AP1000 DOCUMENT NO. APP-GW-GLN-003	REVISION NO. 0	Page of	ASSIGNED TO W-A. Sterdis
---------------------------------------	-------------------	---------	-----------------------------

ALTERNATE DOCUMENT NUMBER: _____ WORK BREAKDOWN #: _____
 ORIGINATING ORGANIZATION: Westinghouse Electric Company
 TITLE: Hydrogen Igniter Locations

Title: Hydrogen Igniter Locations

The purpose of this AP1000 Standard Combined License Application Technical Report is to correct or modify the elevations or locations of certain hydrogen igniters within the AP1000 hydrogen control system. Igniter locations are being adjusted consistent with the physical plant layout. Their number and electrical power grouping are not changed.

Figure 6.2.4-5

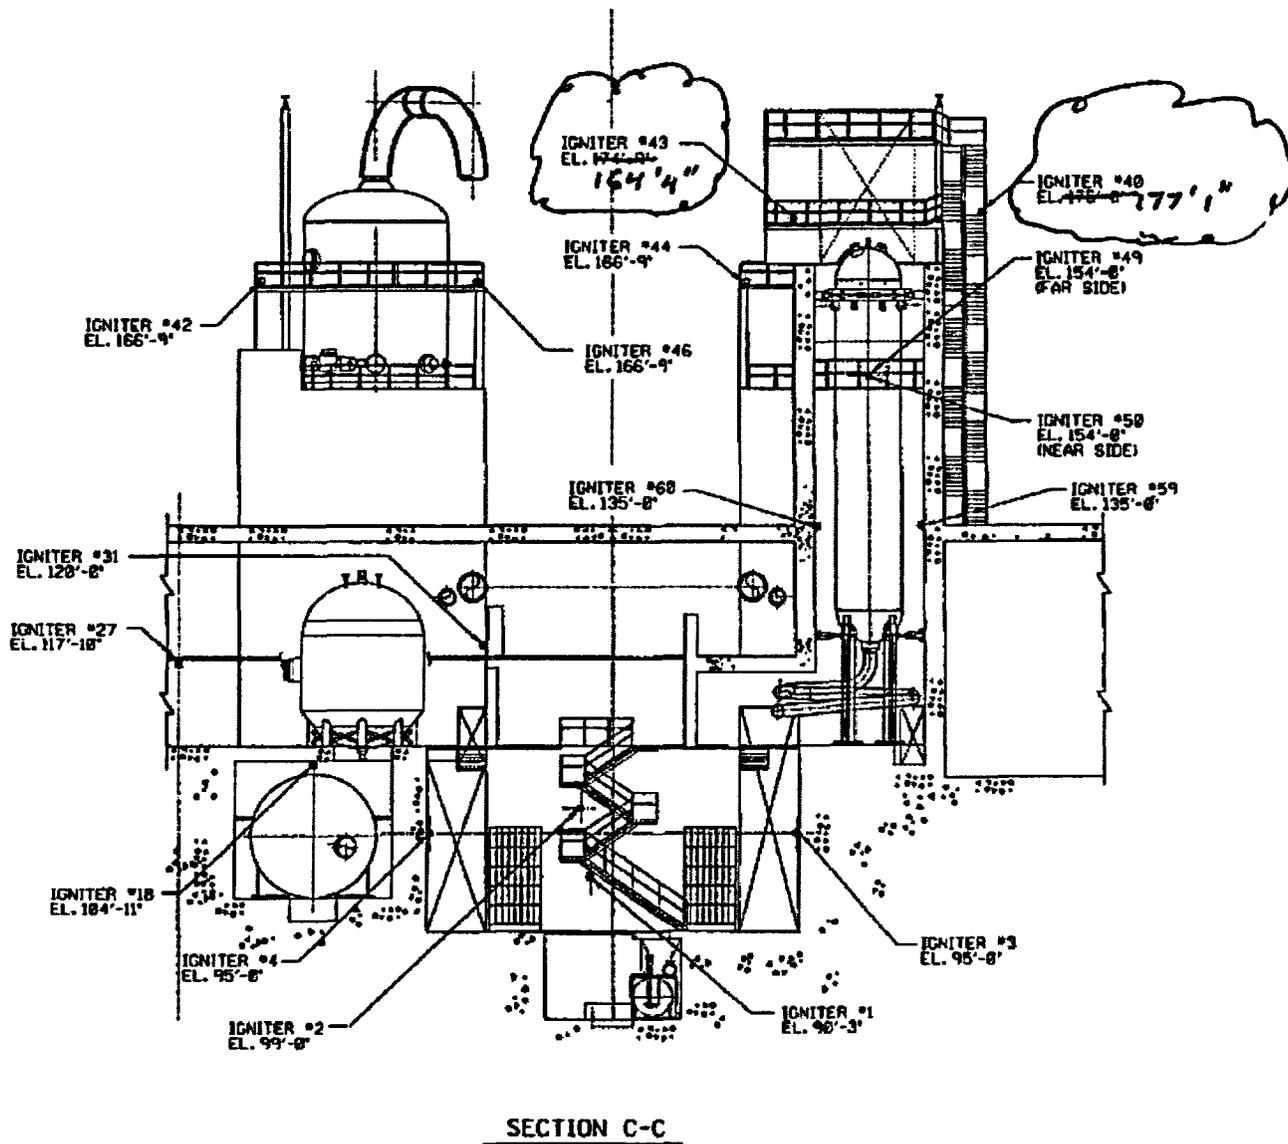
Revise Figure 6.2.4-5 as follows:

Figure 6.2.4-9

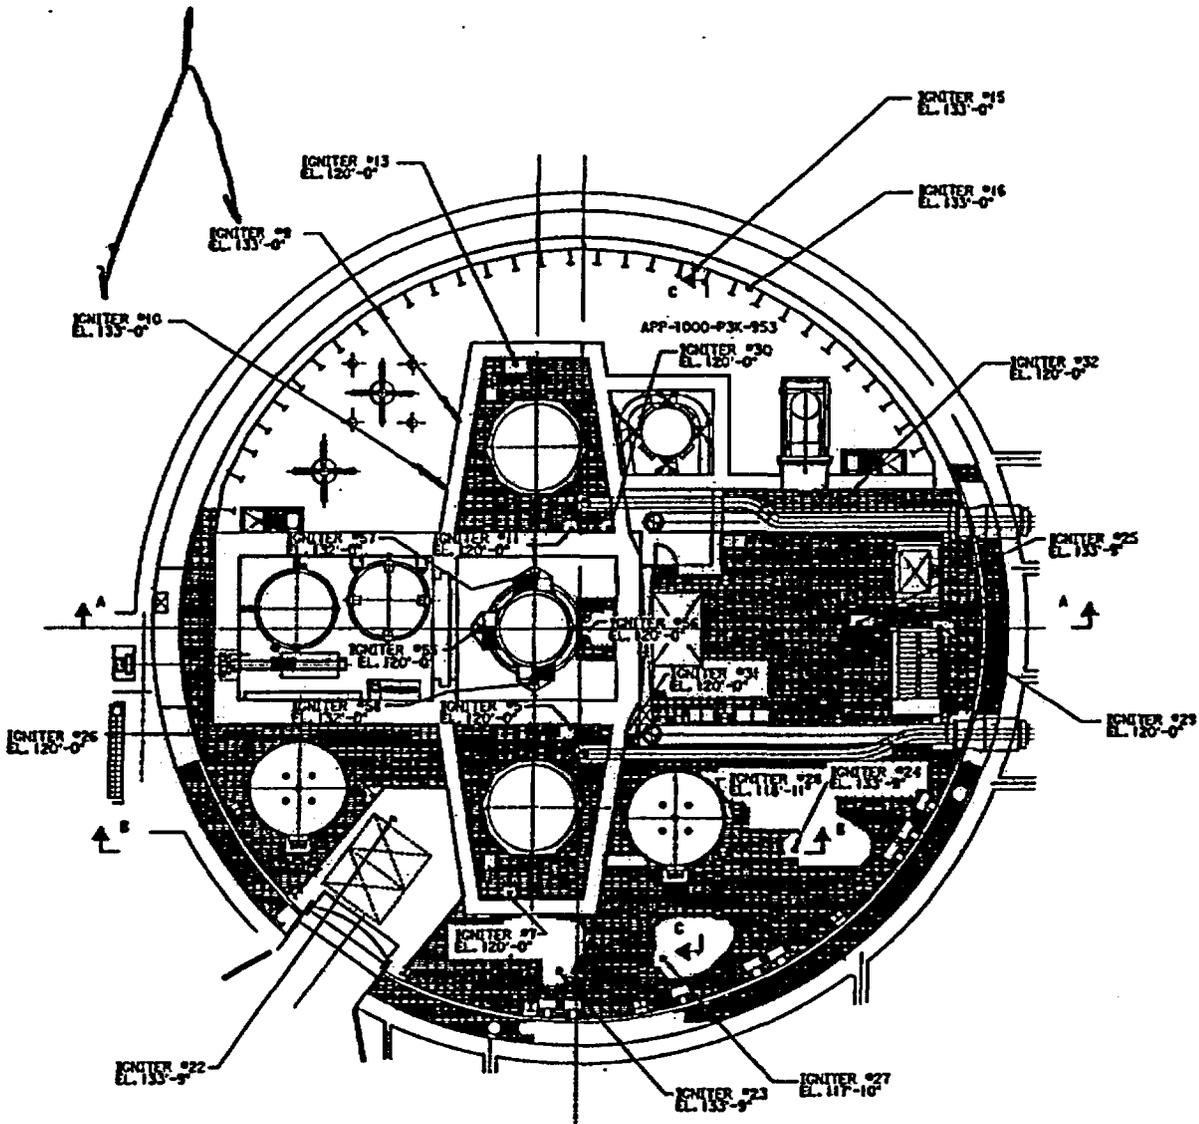
Figure 6.2.4-9 Revise Figure 6.2.4-9 as shown on the next page.

**IGNITER S #9 AND #10 ARE BEING MOVED
CLOSER TO VENTS ALONG THE SG 01 WALL.**

Figure 6.2.4-10

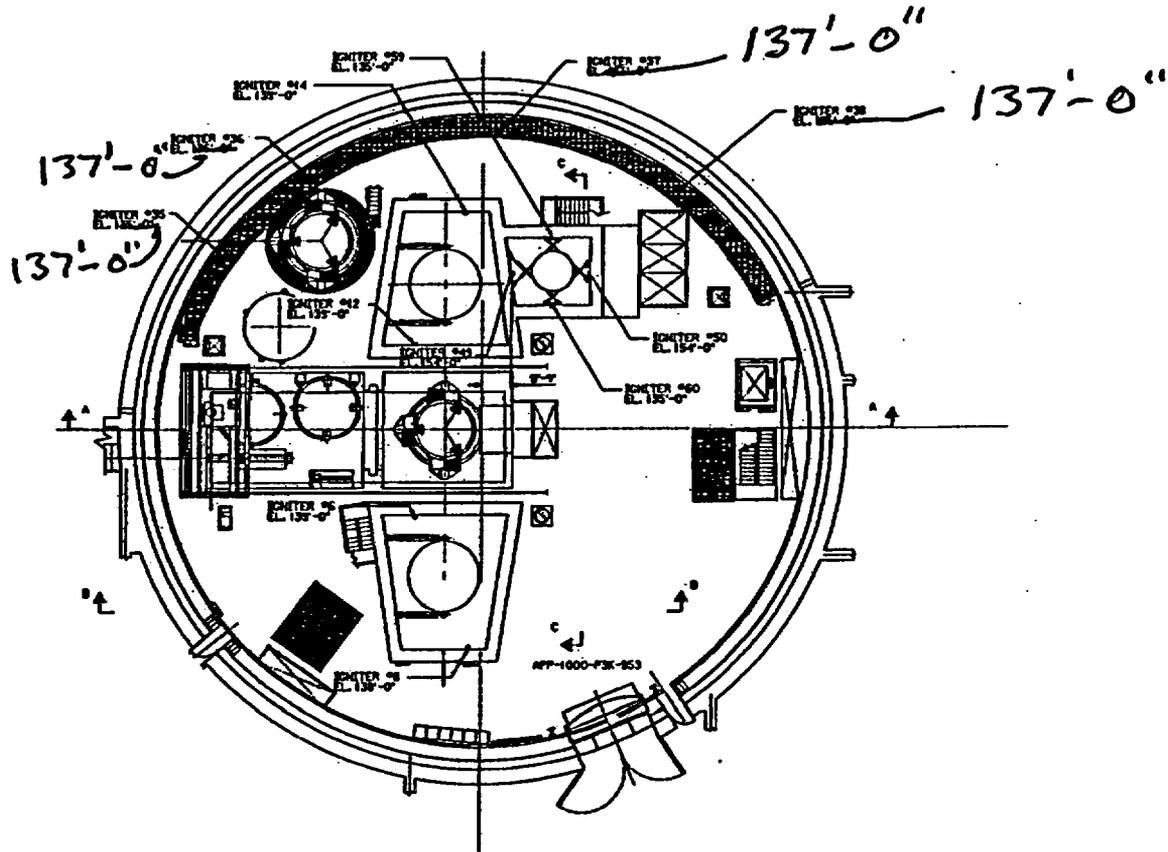
Figure 6.2.4-10 Revise Figure 6.2.4-10 as follows:

Figure 6.2.4-11

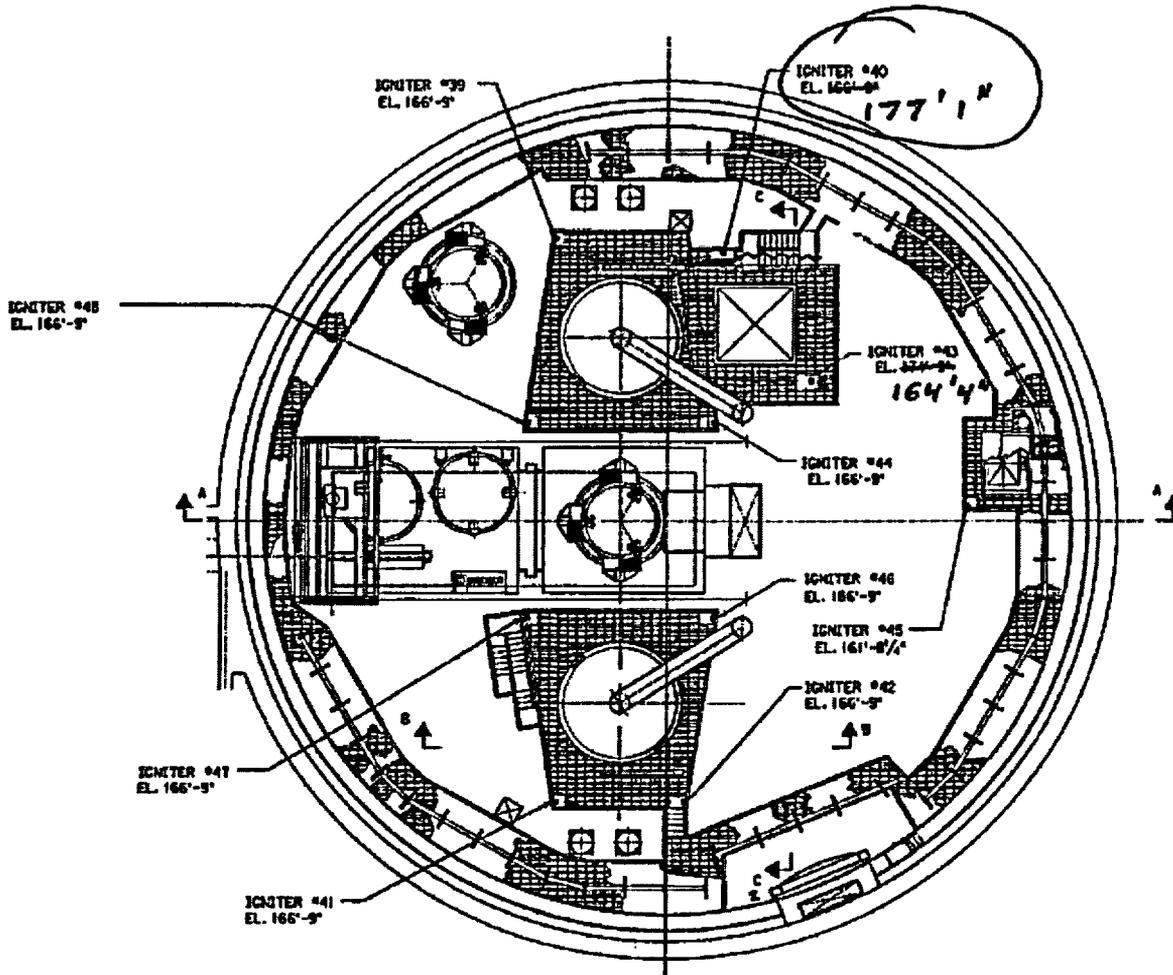
Revise Figure 6.2.4-11 as follows:

Figure 6.2.4-12

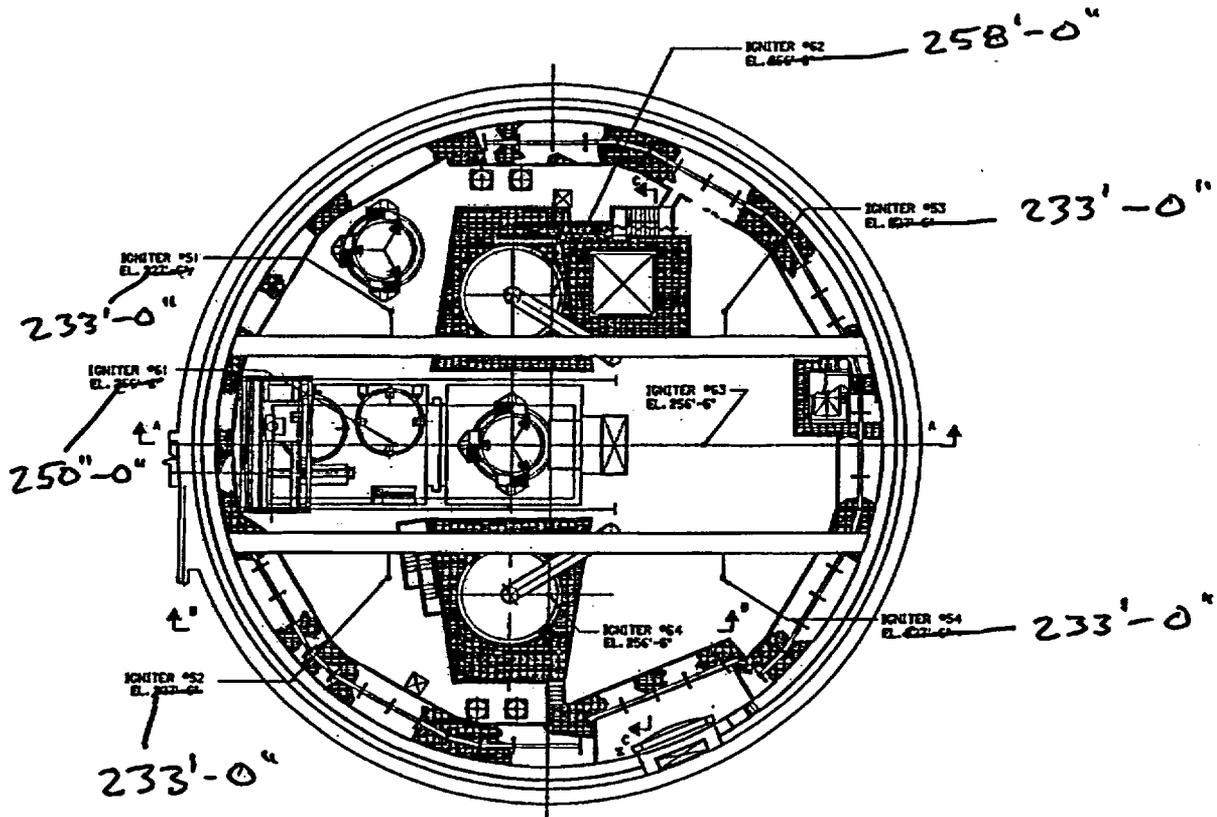
Figure 6.2.4-12 Revise Figure 6.2.4-12 as follows:

Figure 6.2.4-13

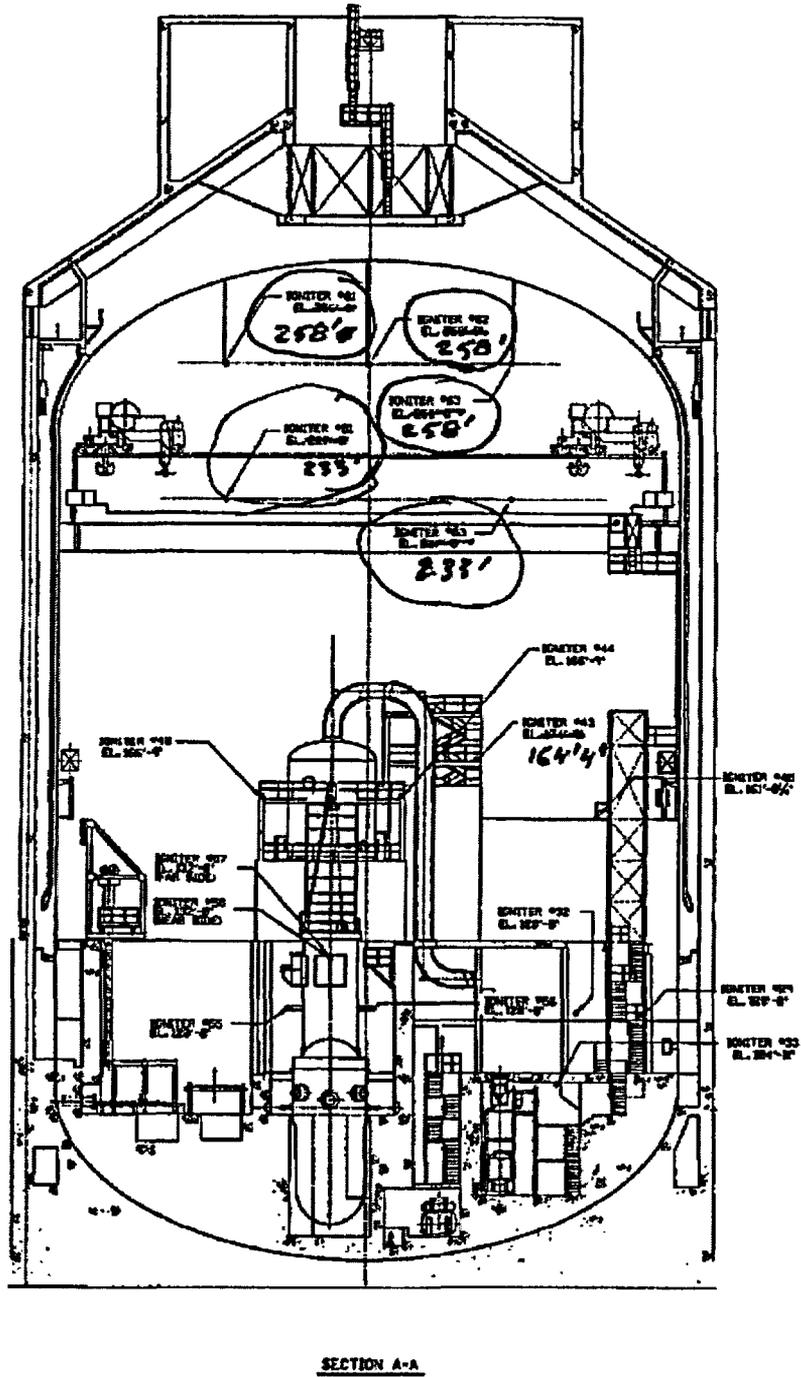
Figure 6.2.4-13 Revise Figure 6.2.4-13 as follows:
